HASTINGS PLANNING COMMISSION A G E N D A

Monday May 4, 2026

Subject: North Ridge Estates Condominiums PUD
[Newly named Thornapple Meadows
Condominiums]

Request: *Special Use Permit/Site Plan Review –
Pennock Gardens*

Landscape Plan

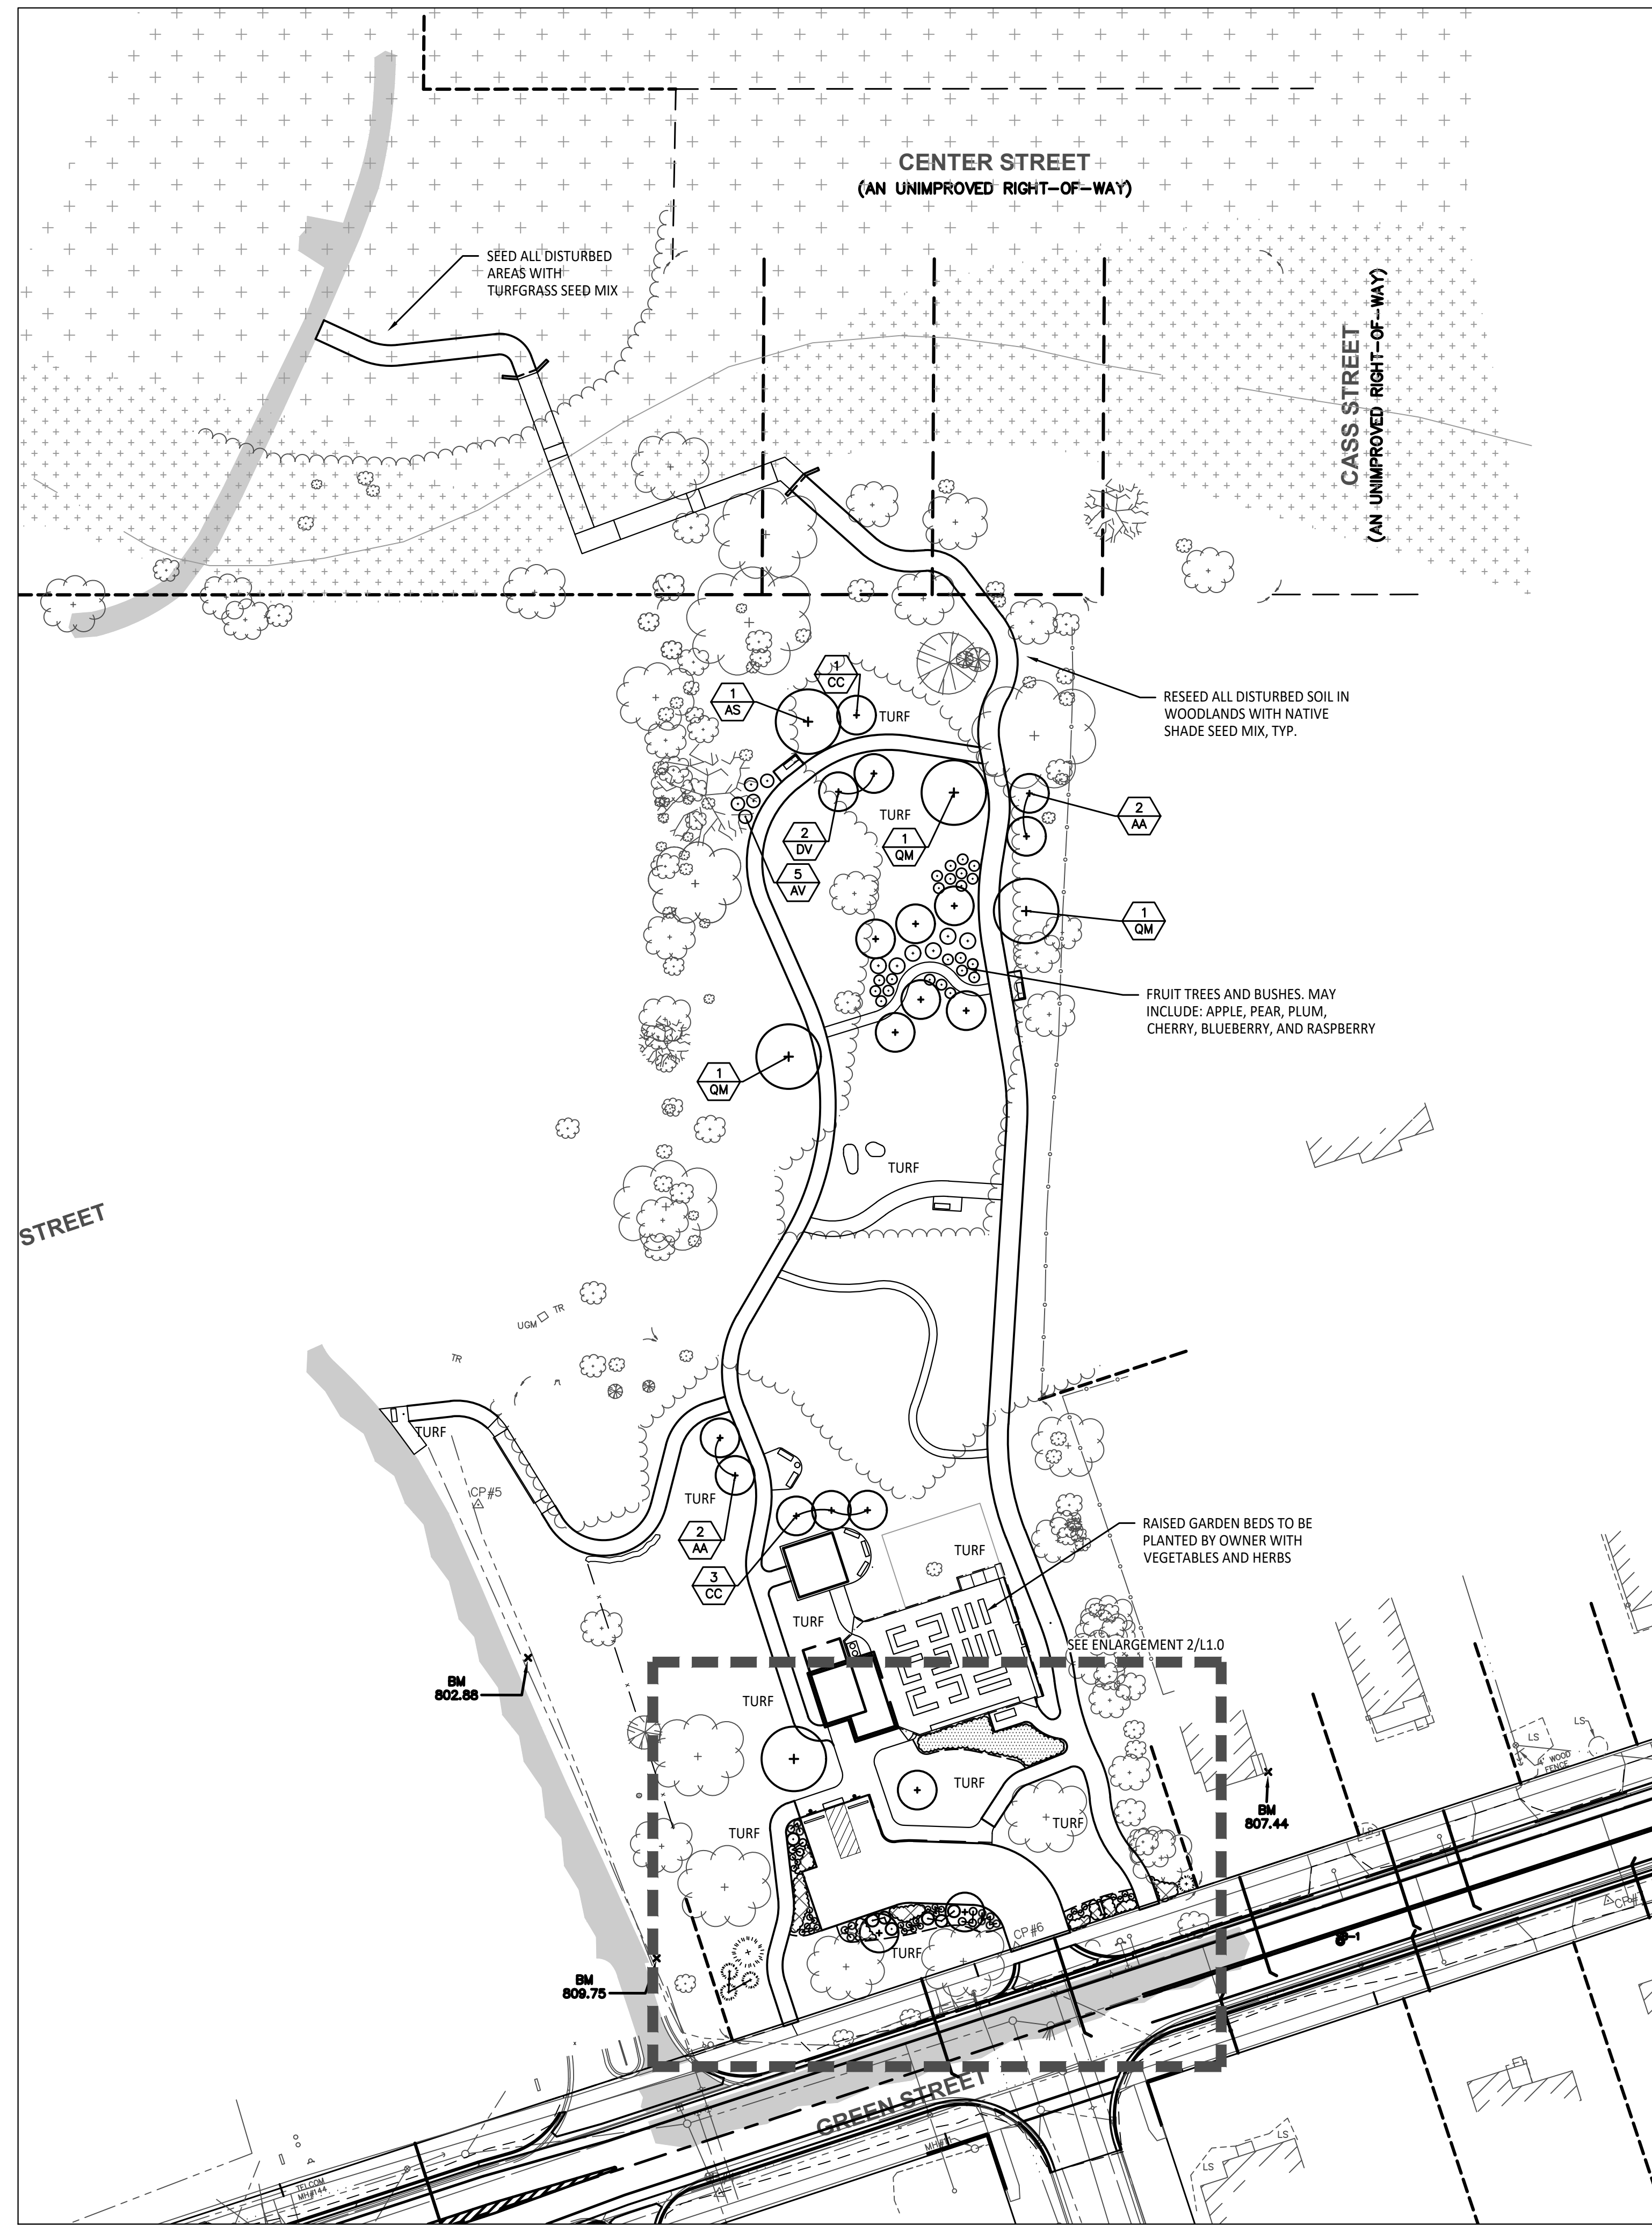
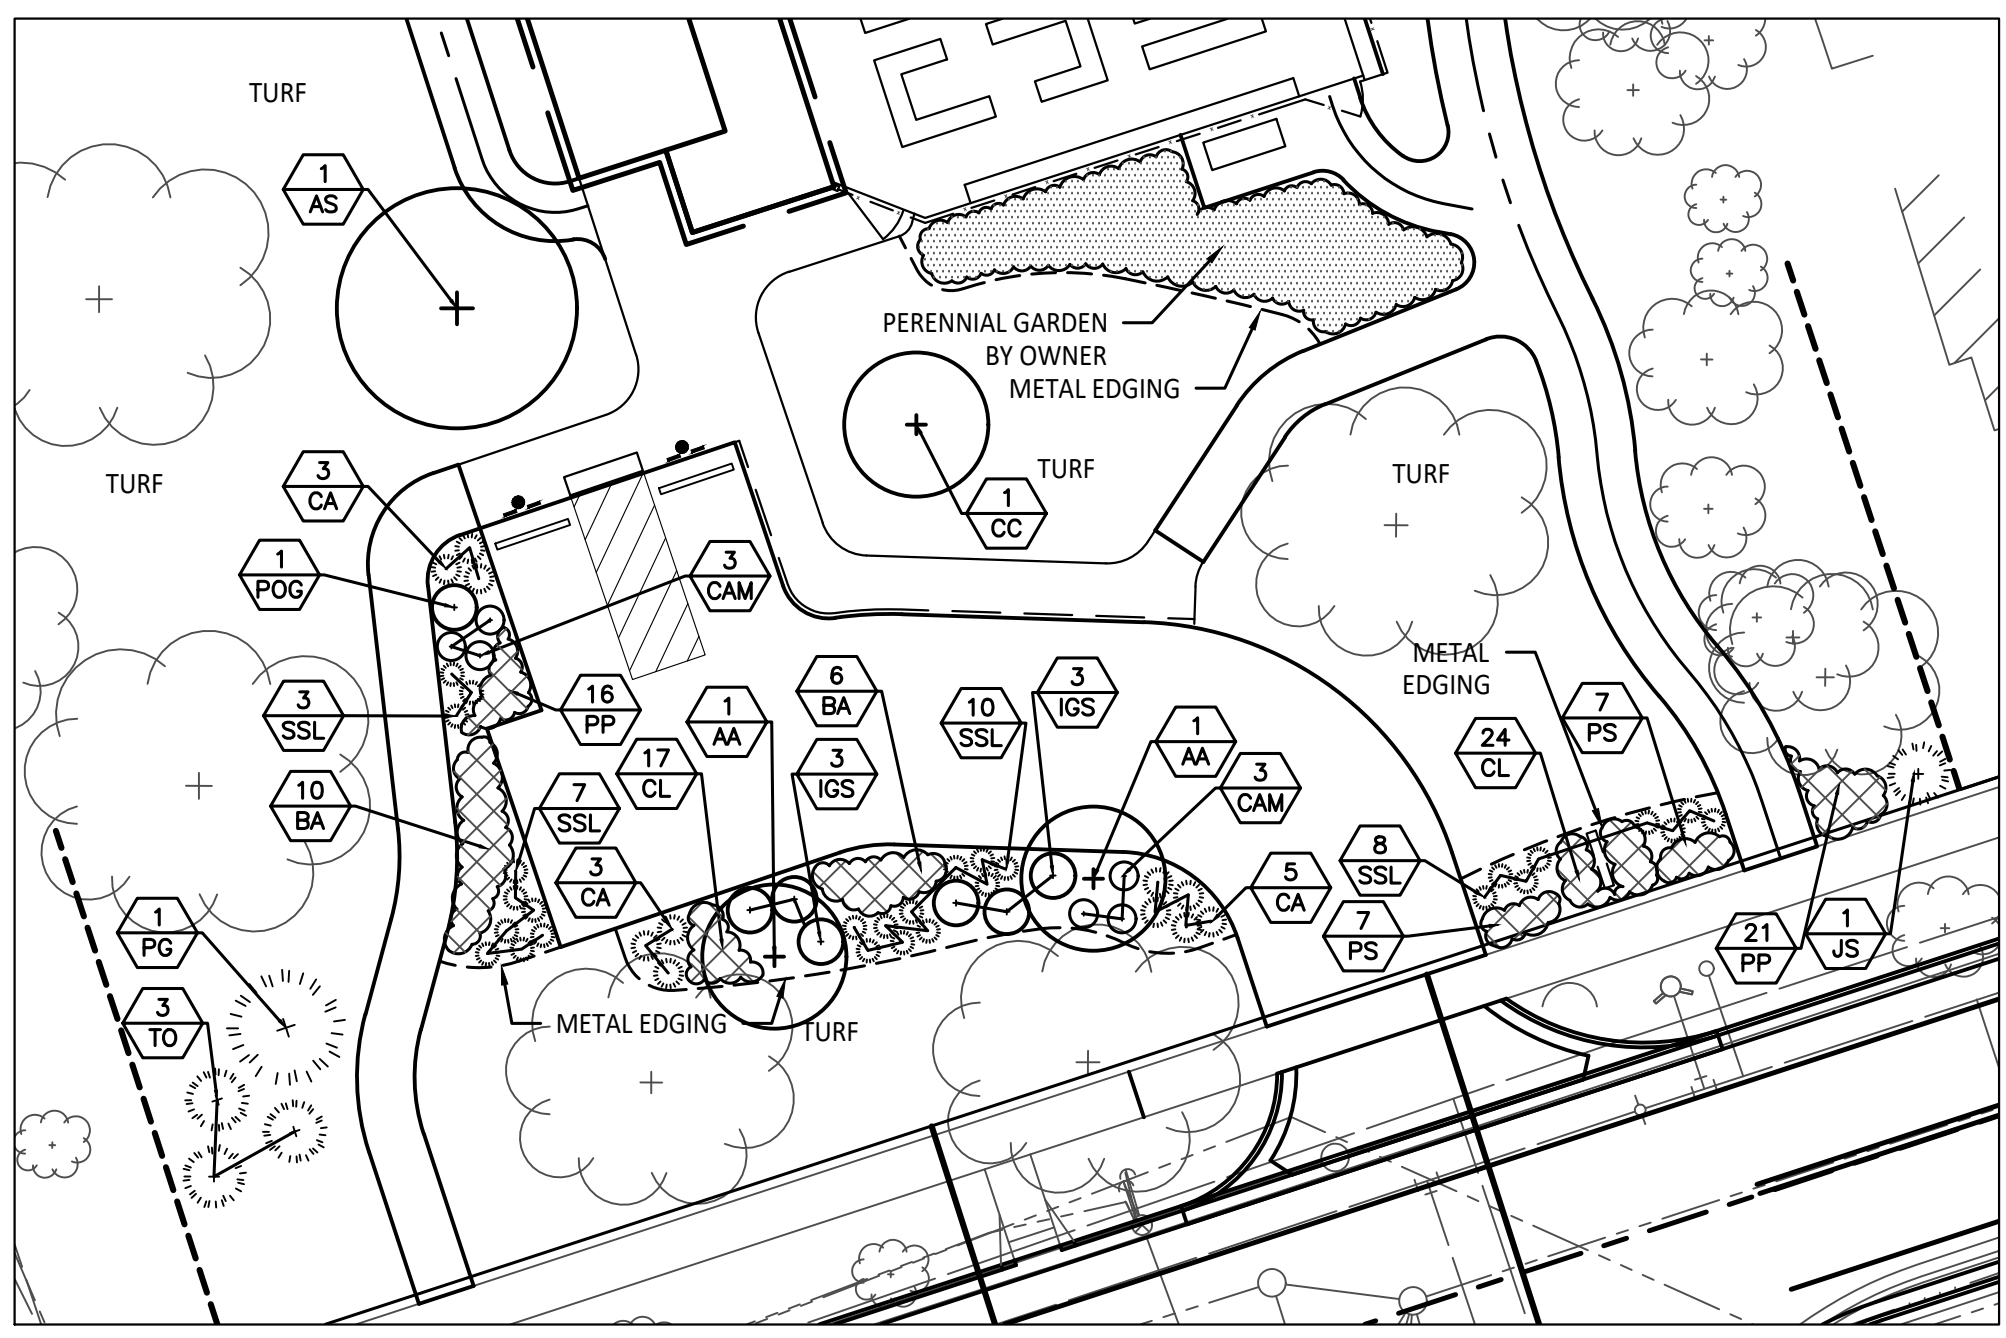
- No screening or landscape buffer zone is required on the subject site.
- Section 90-1011 requires the following front yard landscaping along W. Green Street – 4 canopy trees, 7 evergreen trees, 4 ornamental trees, 15 shrubs; **compliance cannot be confirmed.**
- **Per Section 90-1007, the Planning Commission may modify the landscaping/screening requirements in consideration of existing on-site vegetation and on-site/adjacent land uses.**

ELECTRICAL SITE PLAN

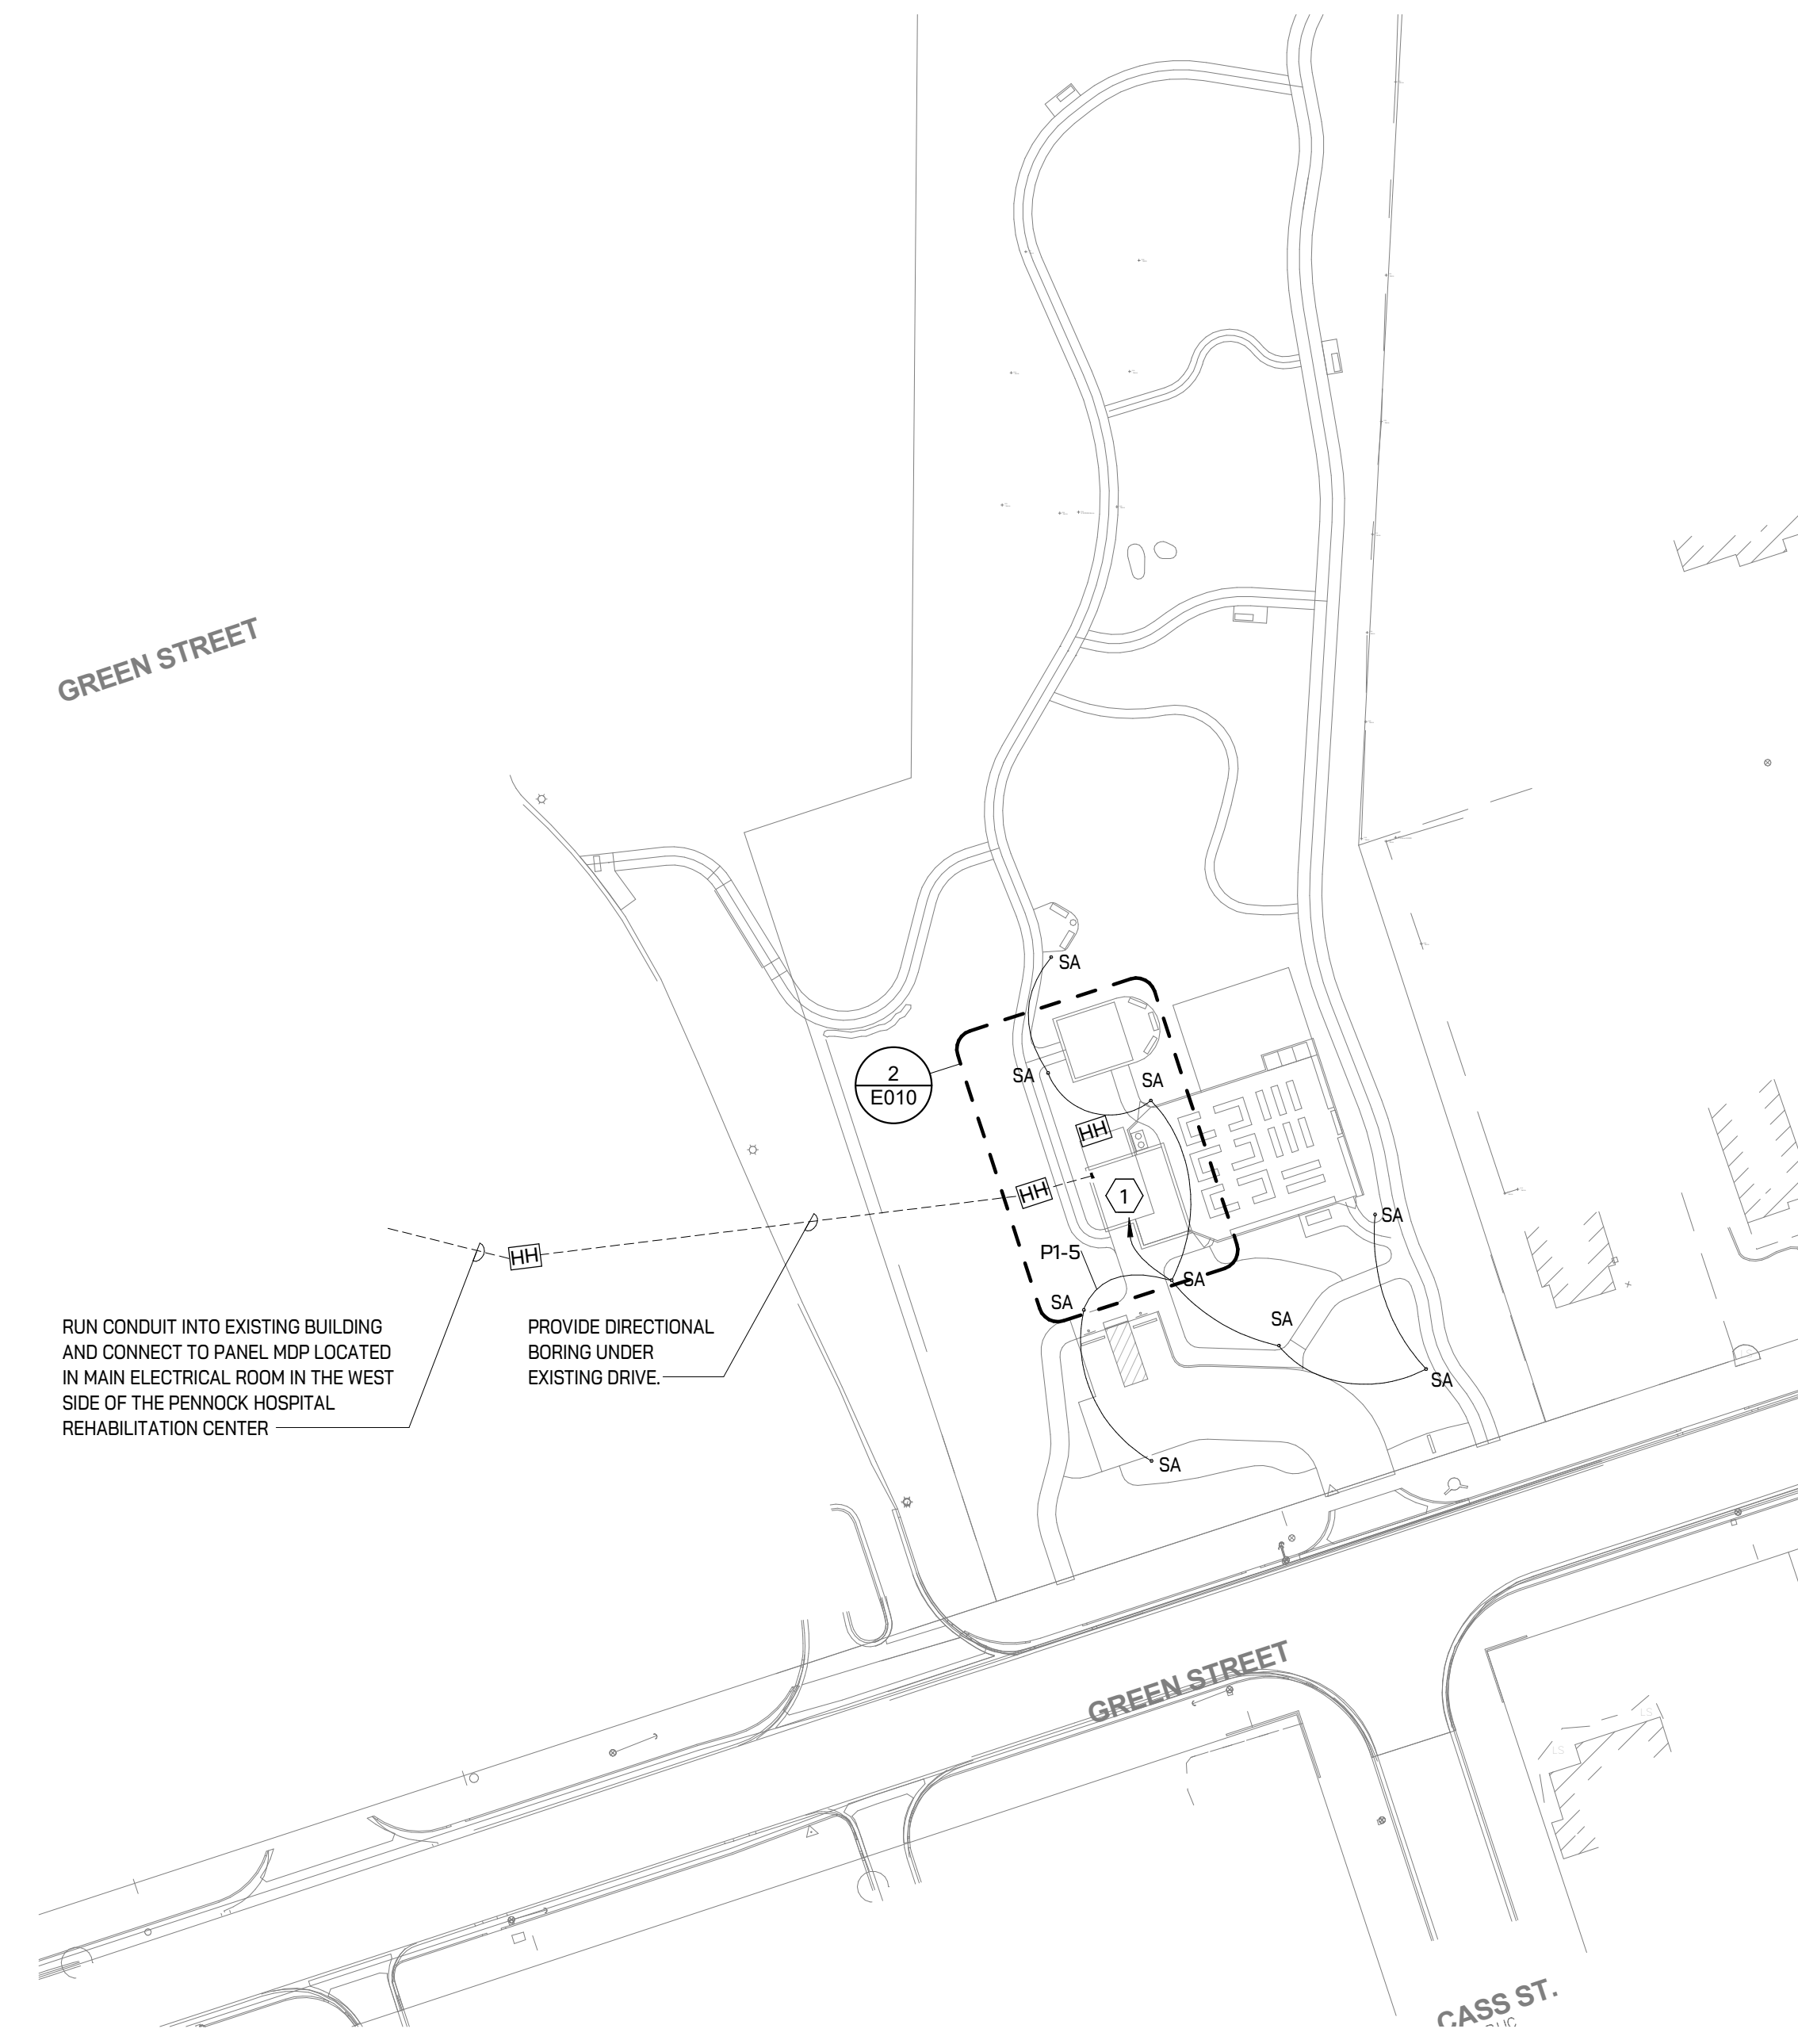
- **Required Parking**
 - No additional parking is required to serve the proposed accessory use.
 - The two (2) barrier free parking spaces provided are at the applicant's discretion.
 - The proposed parking meets applicable dimensional, maneuverability, and surface standards.
- **The storm water drainage proposal shall be subject to Public Services review/approval.**
- **9-16 ft pole-mounted exterior lights are proposed; compliance with sharp cut-off fixture type requirement cannot be confirmed.**
